Title		
Rocket IO & Cable Drivers		
Size	Document Number	Rev
C	DK-Technologies PT8612 HD test pattern generator	1.5
Date:	Thursday, July 19, 2007	Sheet 3 of 5

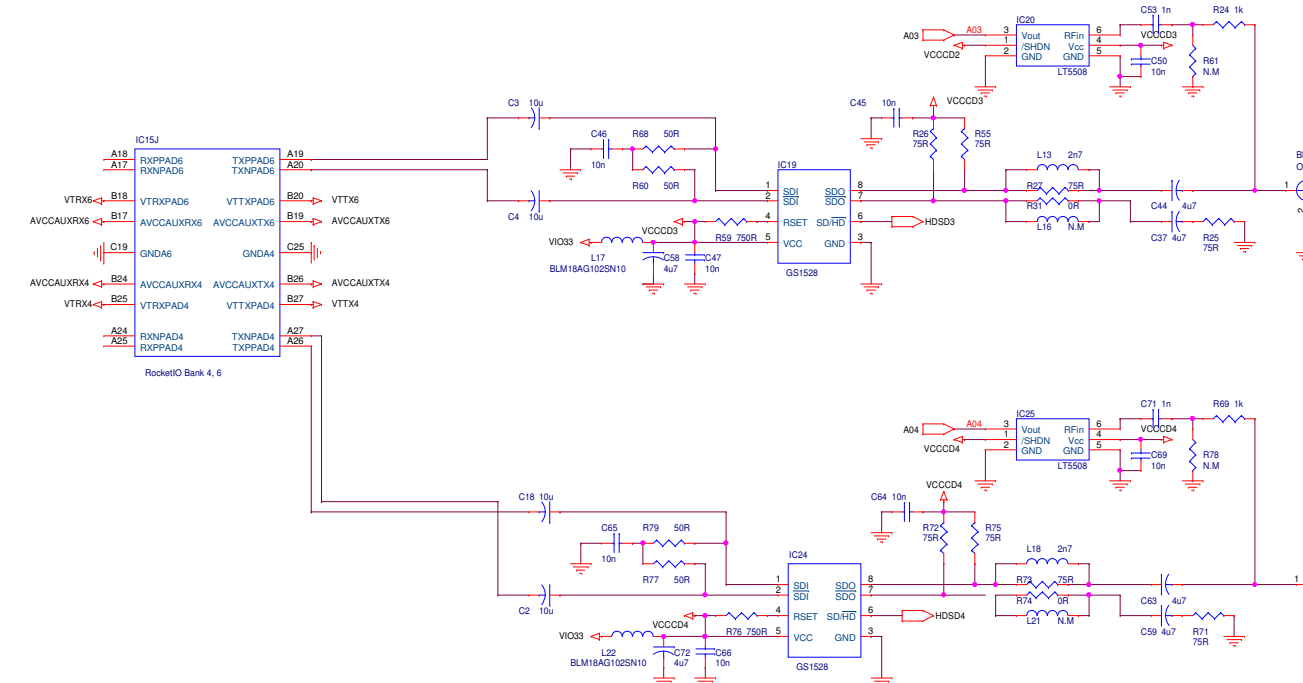
IC4,IC7,IC20, IC25 og
tilhørende modstande og
kondensator ikke monteret

Impedence of 4 output channel is changed to 75ohm
